# System Impact Assessment Report

Talbot  
Wind Generation Station (WGS)

**CAA ID 2008-335**

*Applicant: Renewable Energy Systems Canada Inc.*

**Figure 1: Setting for Grid Under-frequency Trip Protection**

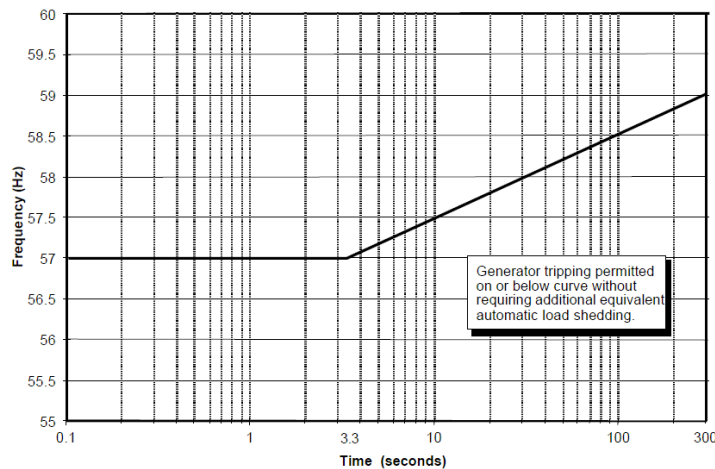
The facility must be capable of operating at full active power for a limited period of time for grid frequencies as low as 58.8 Hz. Generators must not trip for under-frequency system conditions that are below 60 Hz but above 57.0 Hz and above the curve shown in Figure 1.

- (8) The generators should not trip for frequency variations that are above the curve in Figure 1.
- (9) The applicant is responsible for providing real-time telemetering of following variables to the IESO.

**Figure 9: Proposed arrangement of the new SS**

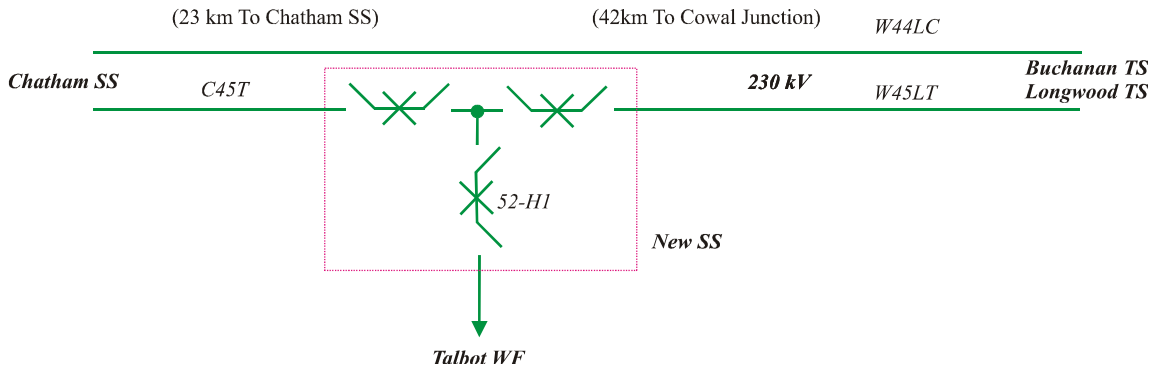
To avoid the possibility of zone 2 time protection operation for stable power swings the PIA study recommended to sectionalize circuit W45LC and build a new Switching Station at the tap to Talbot wind farm. The proposed arrangement of the new switching station is shown in Figure 9. It is recommended to replace the existing directional comparison scheme with line differential protection for the sections of circuit W45LC between new SS, Buchanan and Longwood (W45LT), new SS and Chatham SS (C45T).

The IESO concluded that the proposed arrangement in the PIA is a practical and acceptable approach for solving protection coordination issues and the security of Talbot WF will be improved by connecting to the system when either new section of C45T or W45LT is out of service. Therefore, this SIA study is carried out based on the proposed arrangement and the impact of the proposed arrangement and protection settings on the reliability of the IESO-controlled grid is examined.

- (1) The connection arrangement must be changed to reflect the findings of the Protection Impact Assessment (PIA), i.e., in-line breakers on W45LC should be installed as requested.
